# Technical Service Bulletin

## Camshaft Adjuster 3.0L - DTCs stored and/or oil leaks

15 07 01 2005587/4, Jan. 10, 2007. Supersedes Technical Service Bulletin Group 15 Number 06-05 dated Oct. 9, 2006 due to addition of DTC codes.

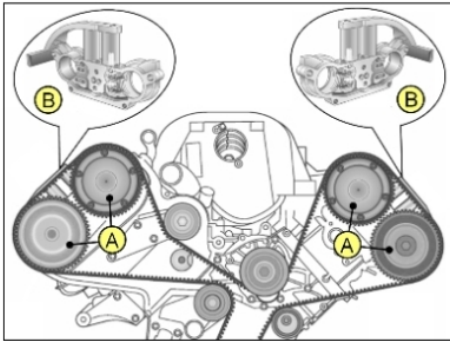
**Do not replace the camshaft adjusters (A) or camshaft adjustment housings (B) because of these DTCs.**

- Follow Guided Fault Finding test plan for diagnosis.
- Erase the DTC memory. *These DTCs only occur during the break-in period of the cylinder head and are not causing the MIL.*

- Check for sufficient oil pressure. If the oil pressure is too low, also check for oil leaks from/around the camshaft adjusters.

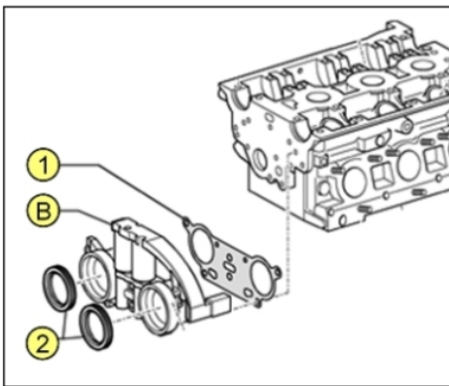
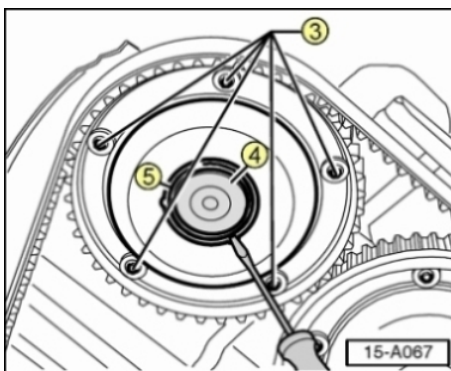
3. In case of an oil leak from a camshaft adjuster, perform the following repairs only on the affected side.

**Do not replace complete camshaft adjusters (A) or camshaft adjustment housings (B).**

- Replace gasket (1) between camshaft adjustment housing (B) and cylinder head.
- Replace both camshaft sealing rings (2) (See Repair Manual, Group 15, "Camshaft and camshaft adjusters, removing and installing")

- Retorque all five outer bolts (3) on all four camshaft adjusters to 15 Nm. (The bolt heads are located on the back side of the camshaft adjuster gears.)
- Replace missing or damaged bolts (part number WHT 003 121).
- Replace caps (4) and O-Rings (5) and secure with securing ring (See Repair Manual, Group 15, "Camshaft and camshaft adjusters, removing and installing")
- Reassemble removed components and complete the repair.
